PRODUCT/PROCESS CHANGE NOTICE (PCN)

PCN #: L-0607-01	DATE: 4-Aug-2006	MEANS OF DISTINGUISHING CHANGED DEVICES:
Product Affected: Please see the attached list of the affected products shipped in tape and reel and in tubes		<input type="checkbox"/> Product Mark <input type="checkbox"/> Back Mark <input checked="" type="checkbox"/> Date Code <input type="checkbox"/> Other
Date Effective: 4-Aug-2006		Lot shipments will have Level 1 Moisture Sensitive Label, and with date code "0630".

ATTACHMENT 1 - PCN #: L-0607-01

PCN Type: Change in Moisture Sensitivity Level

From: MSL 3 Moisture Sensitive Label

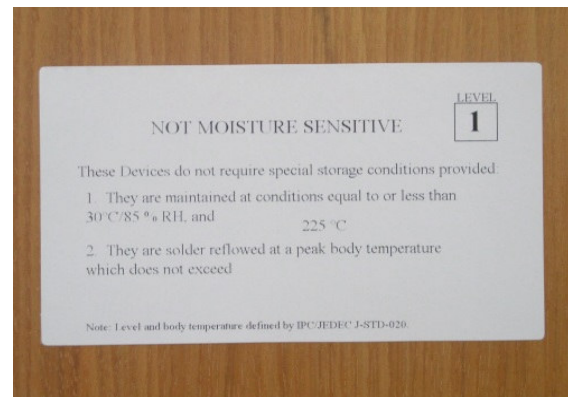
This notification is to advise customers that IDT is converting ICS MSL 3 products shipped in tape and reel, and in tubes, to MSL 1. IDT has completed the verification of the moisture sensitivity classification of ICS products to MSL 1.

The affected products will be shipped without dry pack and labelled as MSL 1 according the JEDEC J-STD-033. There is no change to the assembly material set and the peak reflow temperature. Please refer below for the examples of moisture sensitive labels.
